Project Name: 145 NE 6th Avenue, Turner House, Individually Designated

HISTORIC PRESERVATION BOARD CITY OF DELRAY BEACH --- STAFF REPORT---

ITEM: 145 NE 6th Avenue, Turner House (2016-163) - Certificate of

RECOMMENDATION: Approve with conditions.

Proposed Floor Plan & Elevations

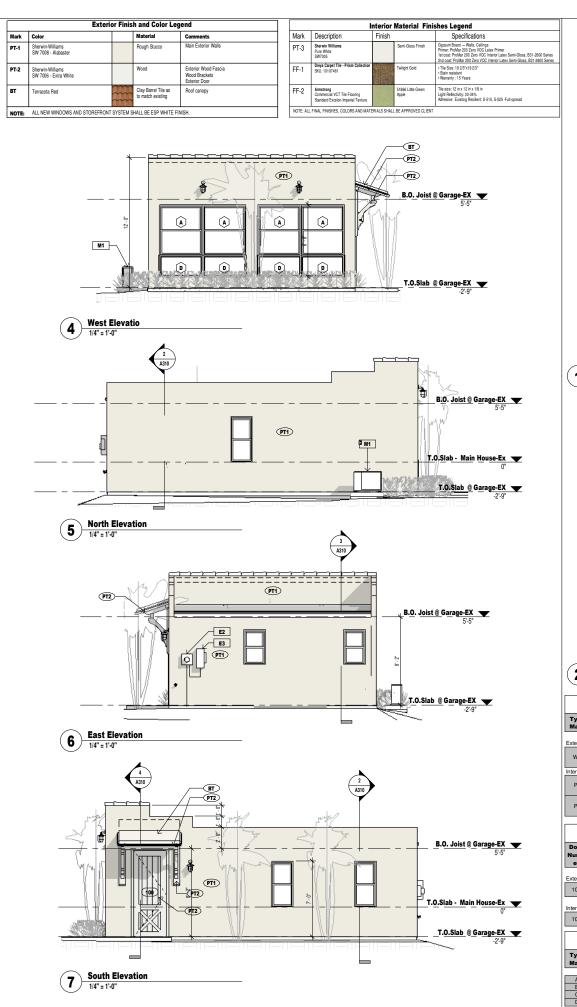
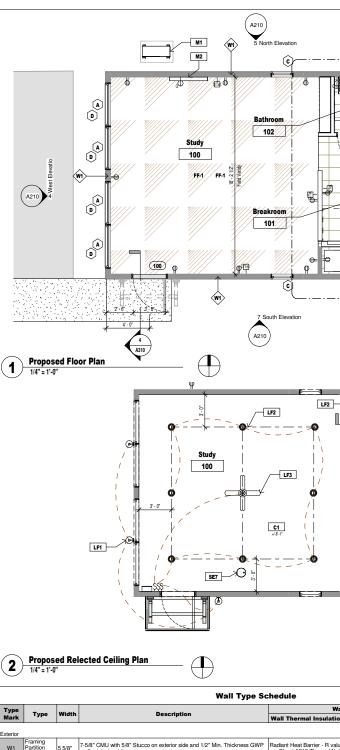
The historic garage was converted from utilization as vehicular parking many years ago, which included a modification to the front elevation prior to the designation. However, the historic characteristics of the building as a garage should be maintained, as these are distinctive. The proposed windows within the original garage door openings strive to provide such sensitivity, but additional detailing should be provided such as identical wood trim around and between the openings. This type of detailing should also be provided around the new windows to ensure the historic character of the windows is retained, as this is frequently lost when windows and their frames are replaced with modern prototypes. The applicant will also need to ensure that the new windows are not mirrored or tinted. In addition to the aforenoted revisions, the tiles on the new shed roof should be a true barrel tile, as opposed to an "S" tile. While this element is new, the tiles themselves should be accurately appropriate. These revisions are suggested as conditions of approval.

In consideration of the applicable Visual Compatibility Standards noted above, the proposed rehabilitation and removal of the rear shed addition is generally appropriate to the structure. The proportions of openings are appropriate and compatible and strive to maintain the existing openings, or provide the appropriate proportions. The materials are also appropriate, and the style will be maintained. There are suggested revisions, however, as noted above, which will assist in fully complying with the subject Standards to ensure that historic detailing is maintained, and compatible for the style. Therefore, positive findings can be made subject to the recommended conditions of approval.

- 1. That the roof tiles be a true barrel tile, not an "S" type tile;
- 2. That the windows not be tinted or mirrored;
- 3. That 6" wide wood trim be added around and in-between the front elevation windows; and,
- 4. That wood trim, including a sill, be added to the windows, similar in dimension as the existing single window on the south elevation.
